Modification Available Performance Enhancement Service Note

E9986E, In-Line Four-Module In-Circuit Test System

The Problem – Bigger idler Pulley to enhance the conveyor belt lifespan.

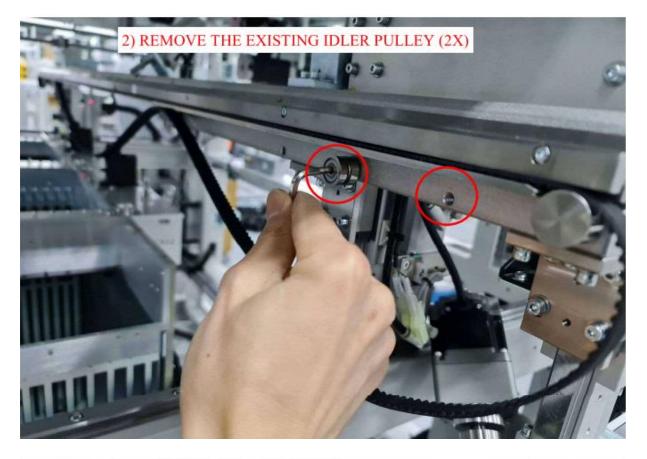
Existing Prolong Lifespan belt may get wear and tear faster than expected (<2 months) if production volume is between 4.5k to 6k daily.

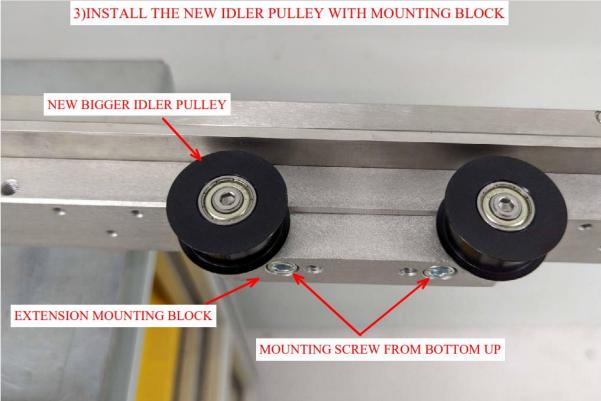
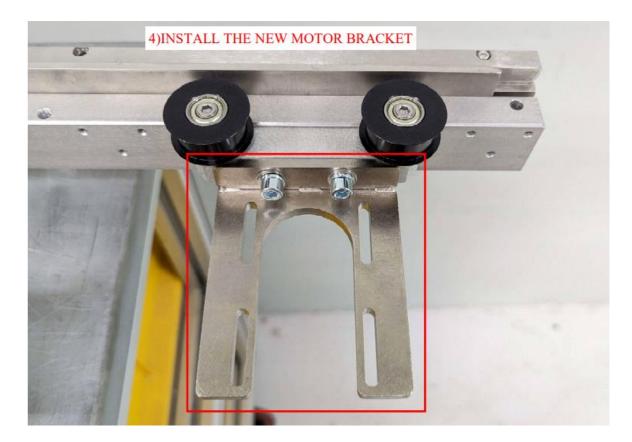
By replacing existing pulley to a new bigger size pulley at motor sides will help to prolong the belts lifespan to about 2x of existing lifespan.

The E9986-63606 is the kit to retrofit to bigger pulley on motor side. No changes are needed for non-motor side.
